## Amended map of the proposed modifications

Map MHB 40: Barton Waterside to Humber Bridge

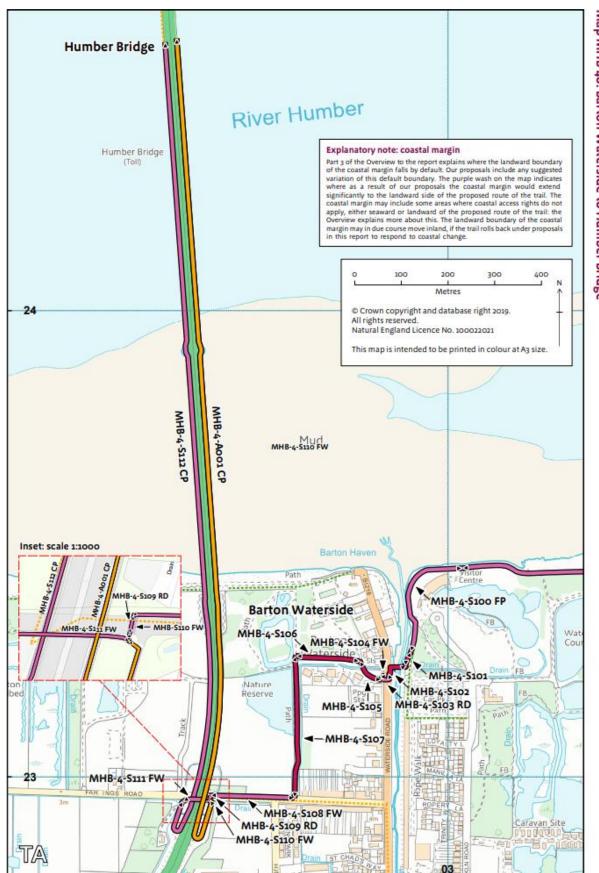
1. Revised map MHB 4o and tables showing a modification to route sections MHB-1-S111 and MHB-4-S112, and MHB-4-A-001. The modification is to move the main route of the trail to the western side of the bridge and the alternative route to the eastern side. This is because although more seaward, the eastern side is closed much more frequently.
